Board of Directors To Sit As Hearing Board

**Thursday, September 12, 2024 at 6:00 p.m.
Section 28 Hearing Re: 10 Lakeside Drive, Stoney Creek
Permit Application No. SC/F,C,A/24/40**

Hearing Report

RE: Hearing under Section 28.1(5) of the *Conservation Authorities Act* for an Application by Sayed Shakour for Development in a Regulated Area of Lake Ontario at 10 Lakeside Drive, City of Hamilton (Stoney Creek) – Permit Application No. SC/F,C,A/24/40

LAYOUT PLAN
SCALE 1:100

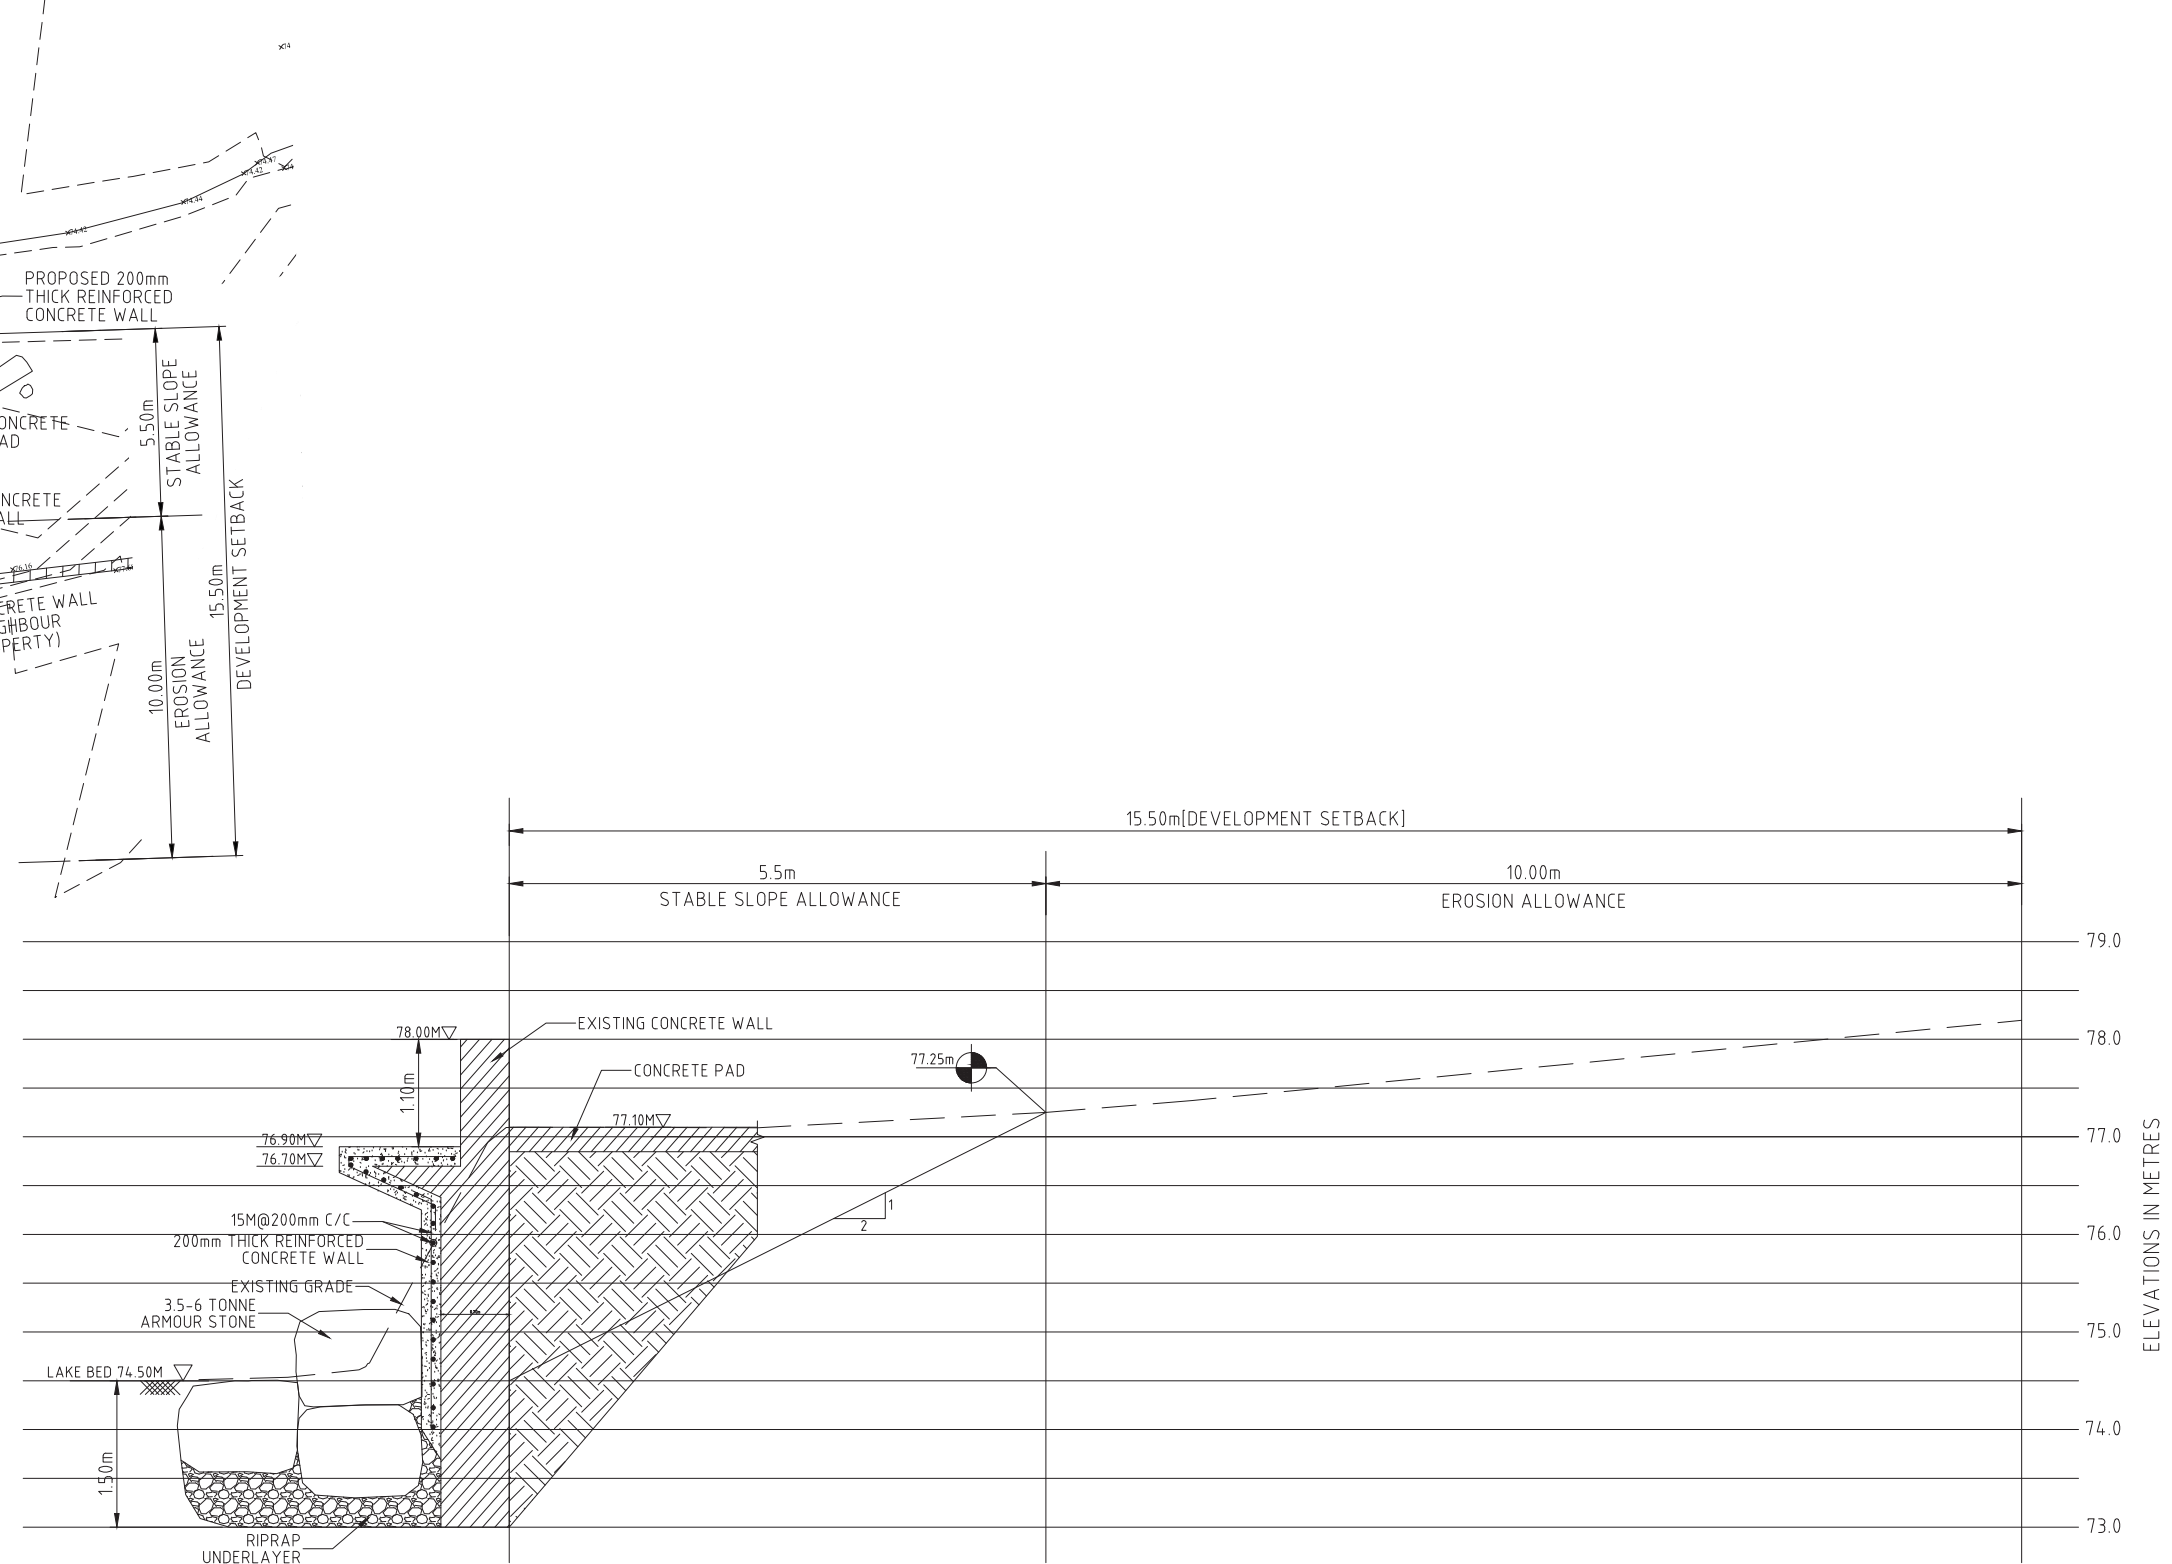
- 5) The erosion hazard setback should be measured from the rear of the proposed wall and illustrated on a section drawing supporting the shoreline hazard assessment.

- AHYDTECH agreed with ensuring the most conservative assessment and applied recession rate of 0.2m/yr while delineating the erosion hazard limit for the property site. The Technical Report and Layout Plan Drawing have been updated accordingly.
